Control House Planning Application – Havant Thicket Reservoir

Application reference: [Planning Application: APP/25/00988](#)

Discharge of Conditions reference: – [Planning Application: APP/25/00989](#)

Figure 6.4: Indicative Layout

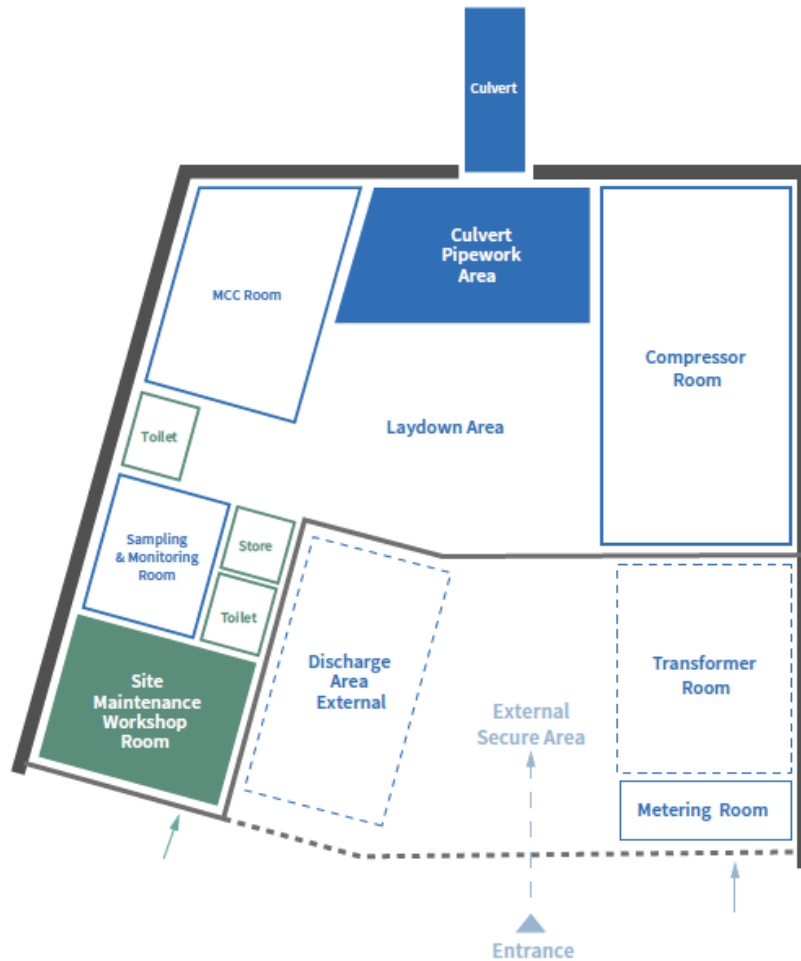
The facility was clearly shown on the indicative layout on page 38, copied below for ease of reference, yet this facility is NOT provided in the new design.

The new Control House layout does **NOT** include a Site Maintenance Workshop Room and this **represents a material change** to the outline design considered and approved by the LPA in 2020/21. This is despite the building footprint having increased from 430m² to 567m².

Given the material change to omit the Site Maintenance Workshop Room from the Control House design it is important that Portsmouth Water make it clear in writing to the LPA that this essential facility for grounds maintenance and external volunteers will be provided on site with ample space, and the location agreed with the LPA.

The LPA should NOT approve the Control House design until it is clear that a suitable alternative location for a Site Maintenance Workshop Room with adequate space and facilities will be provided on site.

If the detail cannot be agreed in writing before consent for the Control House is required, then **the LPA should include a planning condition to ensure that a suitable facility will be provided**, with the minimum size and servicing of the facility agreed with Forestry England and Hampshire County Council (SCP) management to be included in the condition wording. The location must have good vehicle access and ideally where staff and volunteers will have access to a toilet/ wash basin, a sink and power supply.

Figure 6.4: Indicative Layout

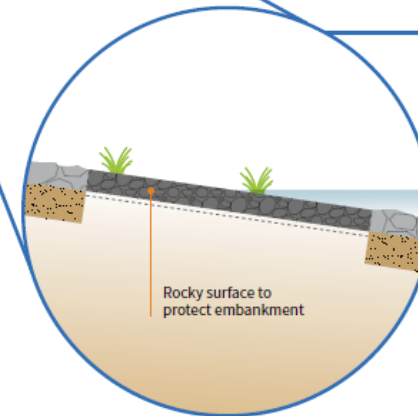
In the 2020 outline design to the reservoir application the Planning Design & Access Statement page 37 confirmed the **Control House would include; "a separate site maintenance and store area** for staff working on the maintenance and upkeep of the land"(Appendix A).
